Cordillera Valley Club

Design Review Board

Meeting Agenda

Cordillera Valley Club Design Review Board *Staff Memorandum*

1 SITE PLAN
1" = 10'-0"

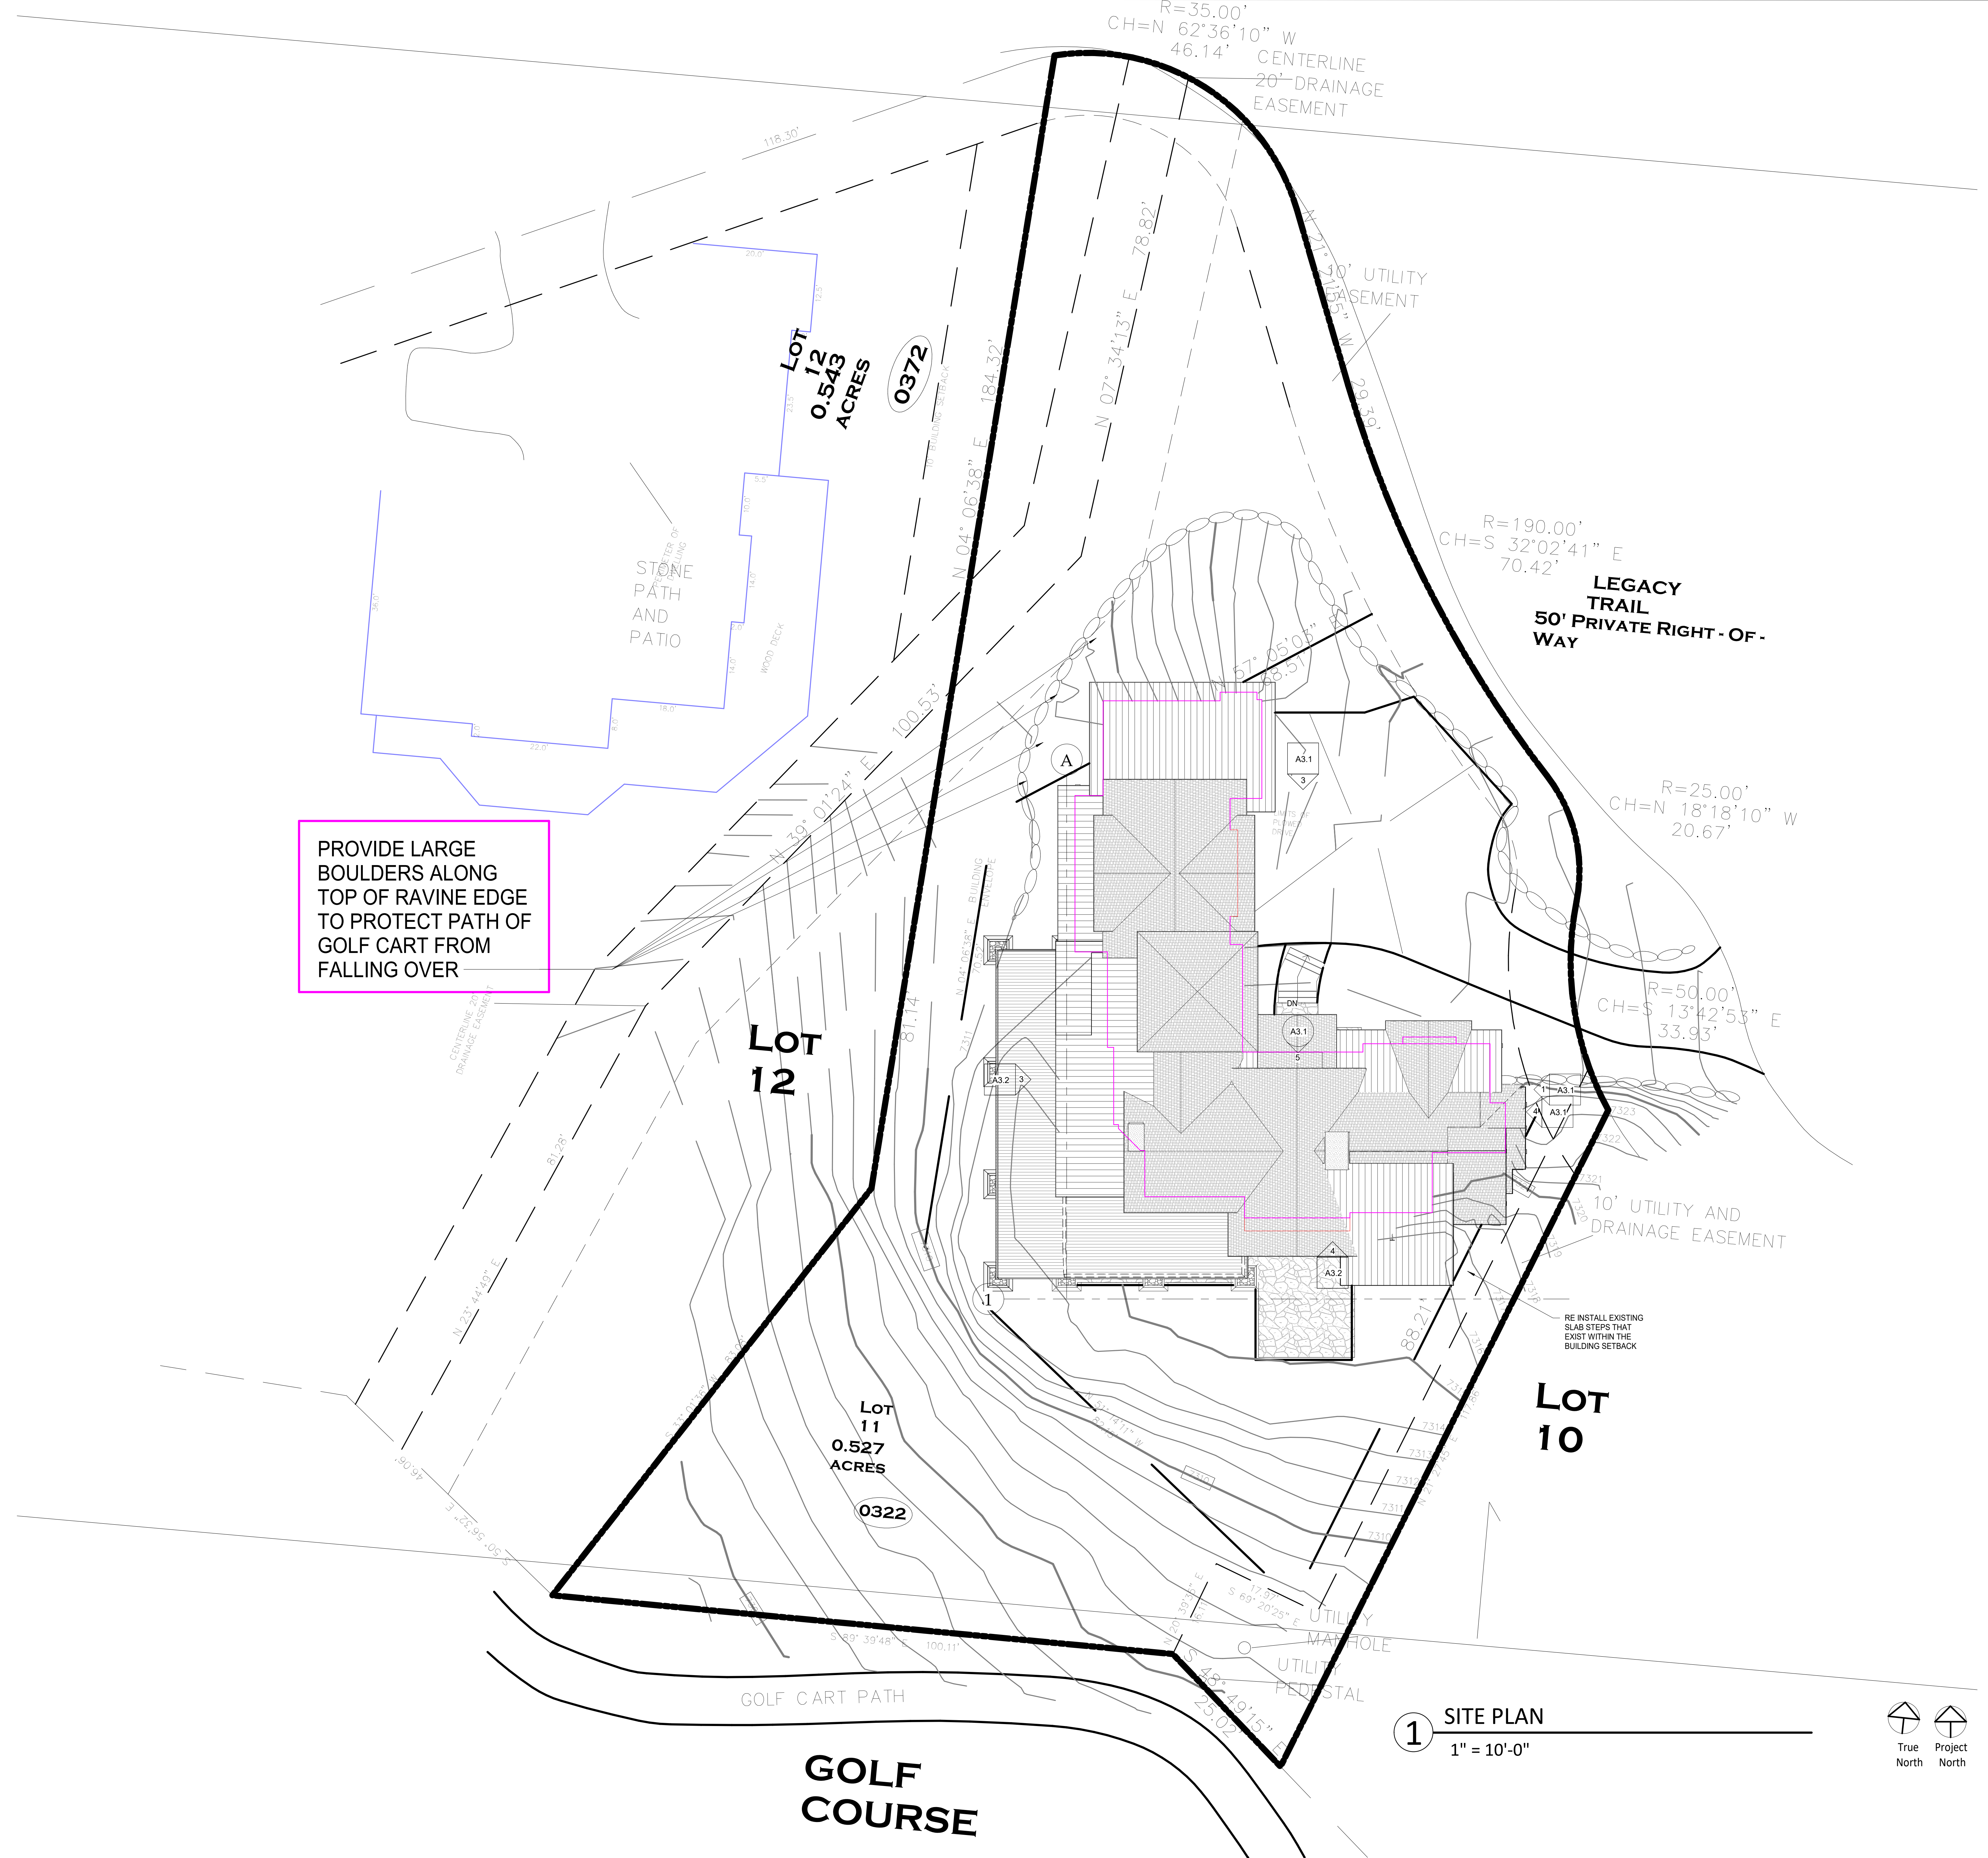
1. Due to the size of the proposed deck and the proximity to the property line and ravine below, the impact of the deck expansion is dramatic. The new stone columns are 14 ft. tall. The Design Guidelines state: *“Balconies and above grade decks should be designed within the mass of the building or as an element of the building structure supported either by angled braces, by building mass below, or by substantial building elements such as stone columns that visibly tie the deck to the ground. In no case shall projecting decks or balconies be supported by narrow posts or columns. Projected decks on the downhill side of the building shall be tied into the existing grade, helping integrate them with the natural grade of the site. Support columns must have stone bases with dimensions consistent with the massing of the home. The underside of balconies and above grade decks shall be finished to be compatible with the building. Consideration should be given to protecting balconies and above grade decks from snow shedding from overhead roofs.”* Staff recommends the DRB provide input on the proposed deck expansion.

2. The proposed plan does not include a full landscape plan. Due to the addition and deck expansion, a landscape plan shall be provided indicating all trees to be removed. A planting plan in accordance with the Design Guidelines shall be provided for review and approval by the Design Review Board. A landscape plan was provided

3 ROOF PLAN
1/4" = 1'-0"

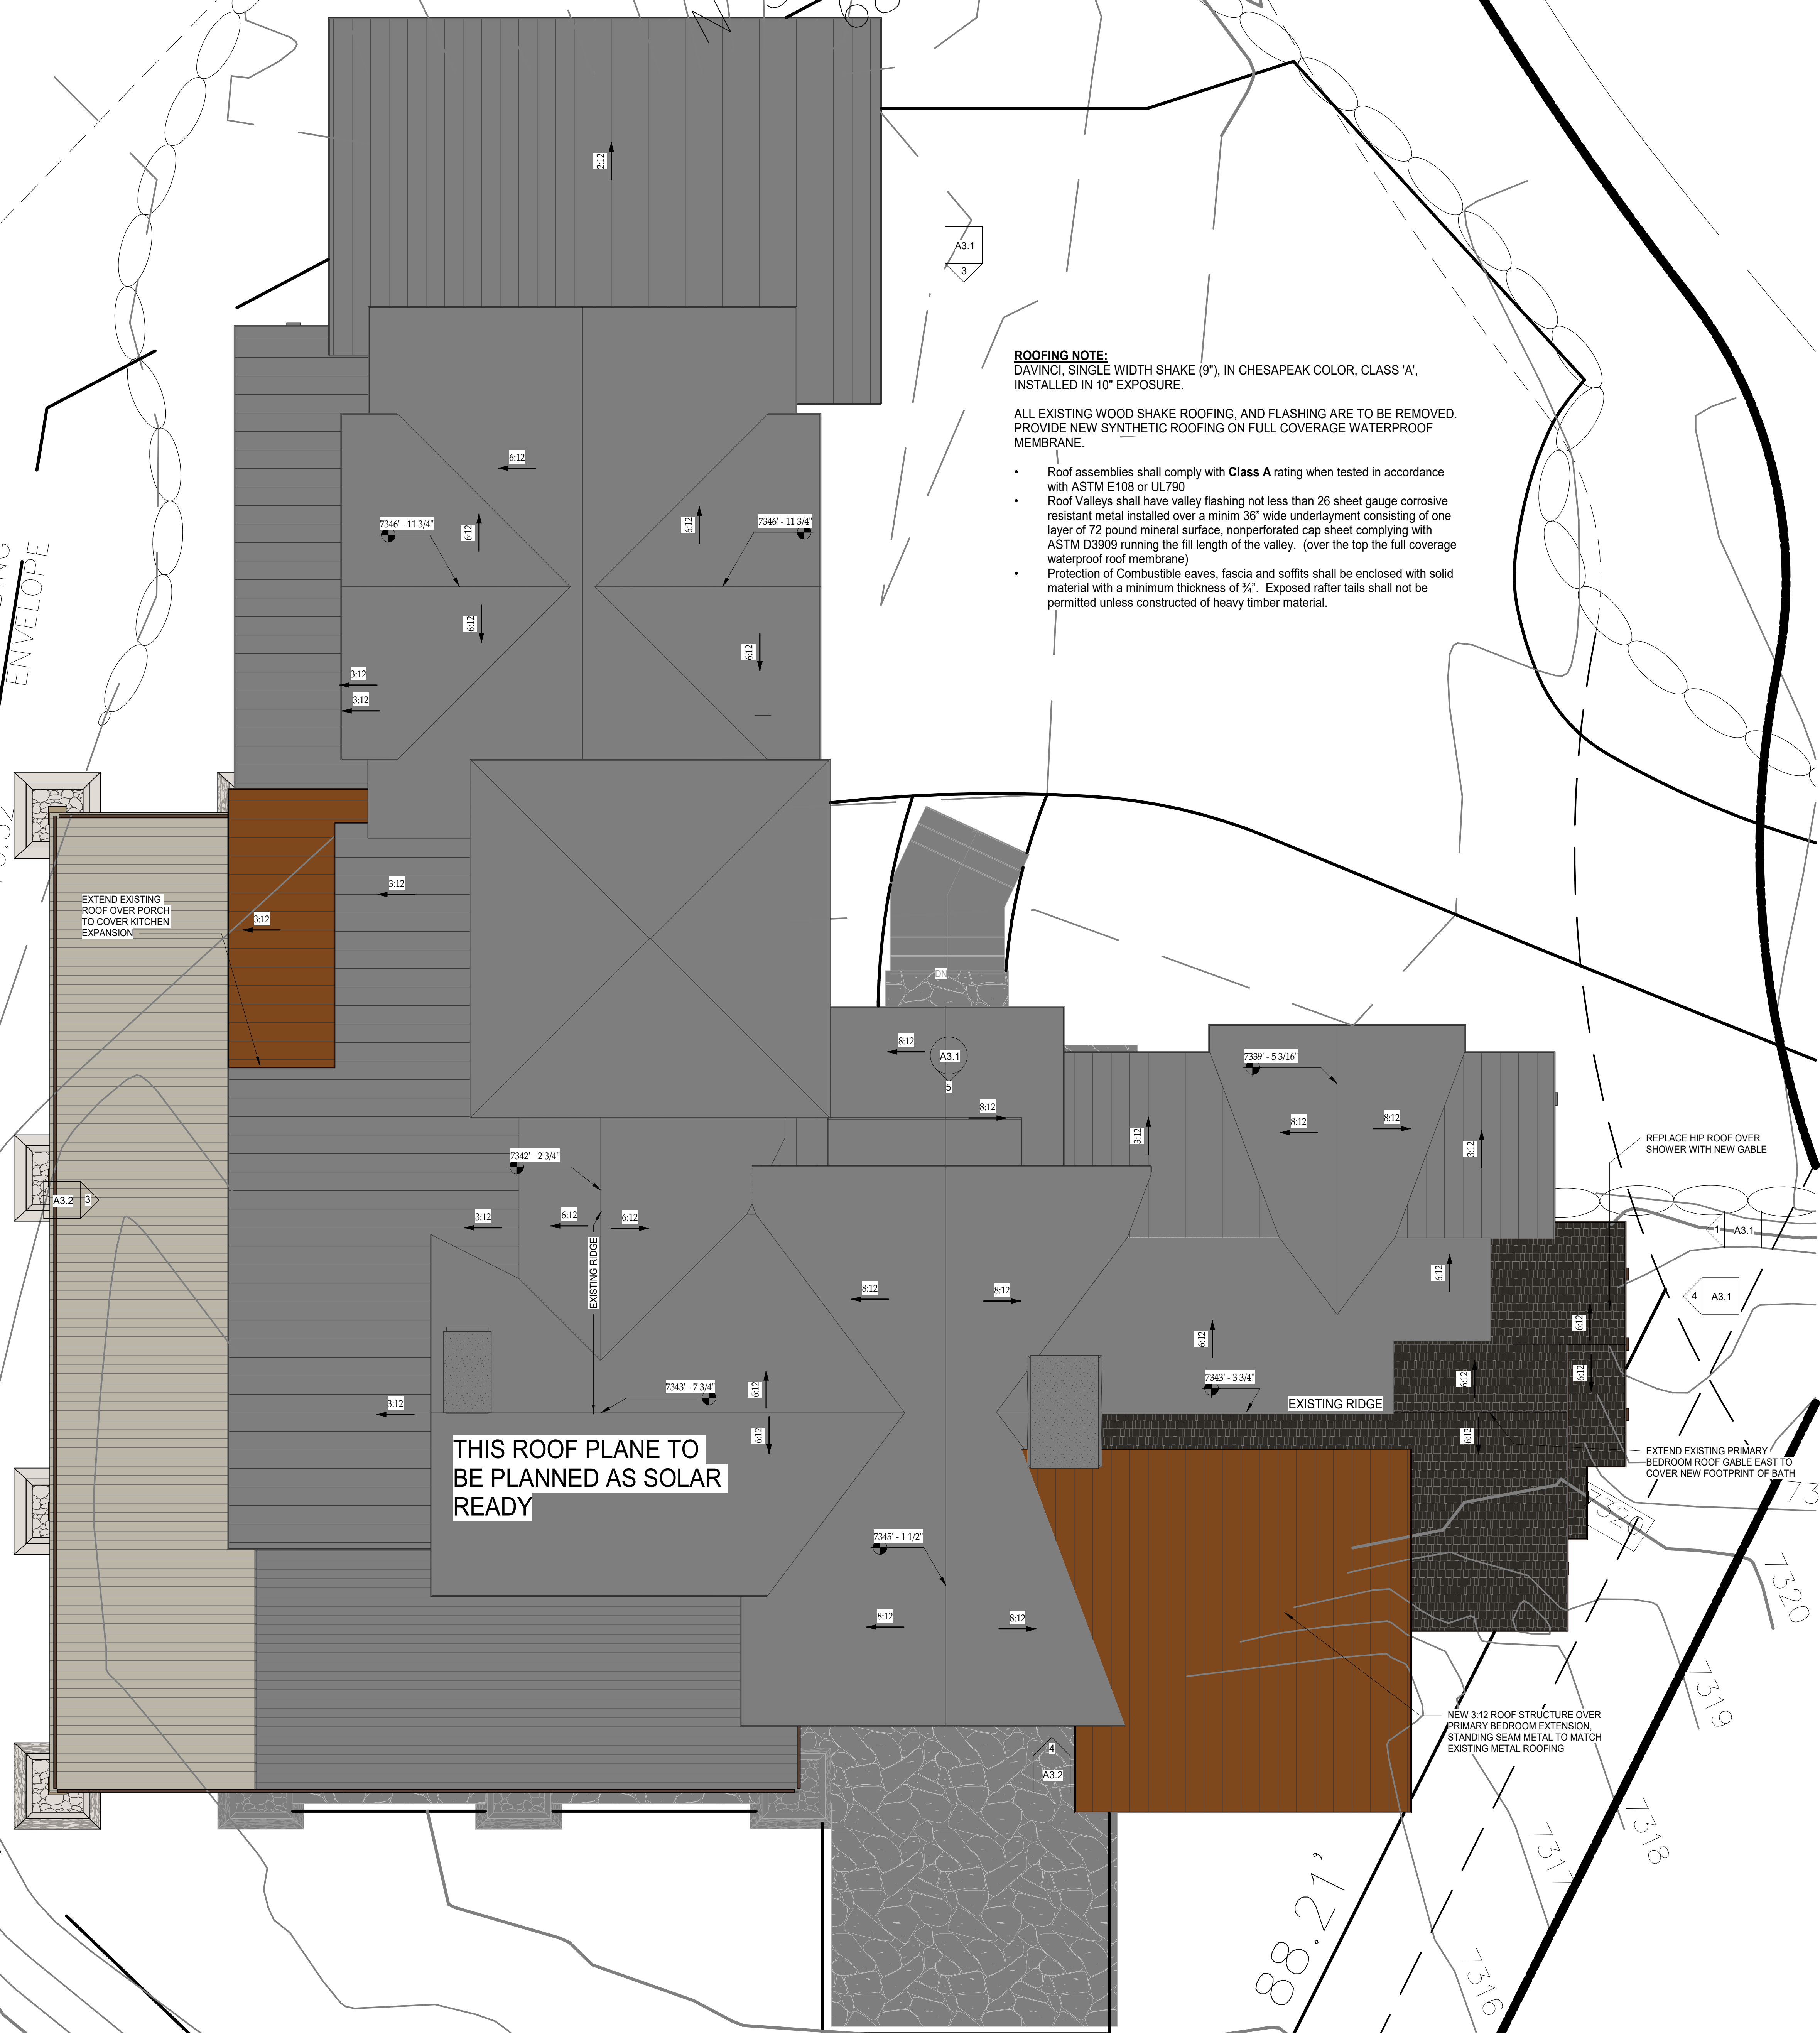
3. The applicant is requesting a Deviation from the Design Guidelines to allow for the roof overhang outside the building environment. In general, the scope of the roof overhang encroachment outside the building envelope are similar to others recently approved by the DRB. The DRB must make the following findings to approve a deviation:
 - a) The proposed encroachment does not affect views from surrounding homesites;
 - b) The proposed encroachment does not substantially reduce the distance between homesites on lots;
 - c) The proposed encroachment allows for a more sensitive design solution by minimizing site grading, the loss of mature vegetation, and/or other considerations, and
 - d) The proposed encroachment will allow for a design that is consistent with the overall design philosophy and design style for the Cordillera Valley Club.
